Access Compliance Report

Public Rights-of-Way

(Curb Ramps)

Intersection ID: 47468	Main Street: MILLSTREAM RIDGE DR	Cross Street: ELENDIL LN	Location: SE
ADA ID: 421CEDEB6127	Ramp Type: Perp	Initial Pass/Fail: Fail	Overall Compliance: No
Severity Score: 30			
Codes/Mitigation Info/Possible Solution		Field Measurements/Component Compliance

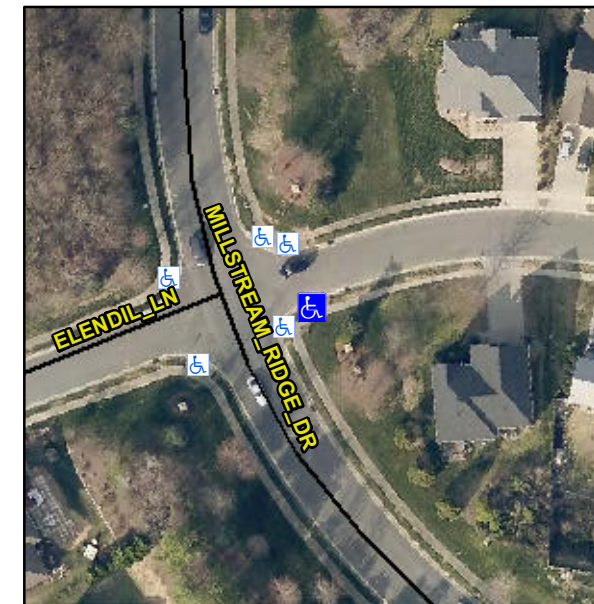
R304.5.1, R304.2.2

Compliance	Description	Data	Compliance	Description	Data
N/A	Ramp Length (in)	48.0	No	Ramp Slope (%)	9.6
No	Ramp Width (in)	32.0	Yes	Ramp XSlope (%)	1.1
N/A	Flare Type LT	N/A	N/A	Flare Type RT	N/A
N/A	Flare Slope LT (%)	N/A	N/A	Flare Slope RT (%)	N/A
N/A	Flare Traversable LT?	N/A	N/A	Flare Traversable RT?	N/A
N/A	Landing Length (in)	N/A	N/A	DWS Provided?	N/A
N/A	Landing Width (in)	N/A	N/A	DWS Contrast?	N/A
N/A	Landing Slope (%)	N/A	N/A	DWS Length (in)	N/A
N/A	Landing X Slope (%)	N/A	N/A	DWS Full Width?	N/A
N/A	Landing Curb? (Y/N)	N/A	N/A	DWS Offset (in)	N/A
N/A	Shared Landing?	N/A			
N/A	Gutter Ponding?	N/A	N/A	Gutter Slope (%)	N/A
N/A	Gutter Lip Ht (in)	N/A	N/A	Gutter X Slope (%)	N/A
N/A	Painted X Walk1?	No	N/A	Painted X Walk2?	N/A
	X Walk 1 Direction	To N		X Walk 2 Direction	N/A
N/A	X Walk 1 Width (in)	N/A	N/A	X Walk 2 Width (in)	N/A
	X Walk 1 Slope (%)	5.6		X Walk 2 Slope (%)	N/A
	X Walk 1 X Slope (%)	2.5		X Walk 2 X Slope (%)	N/A

Remove & Replace Entire Ramp.
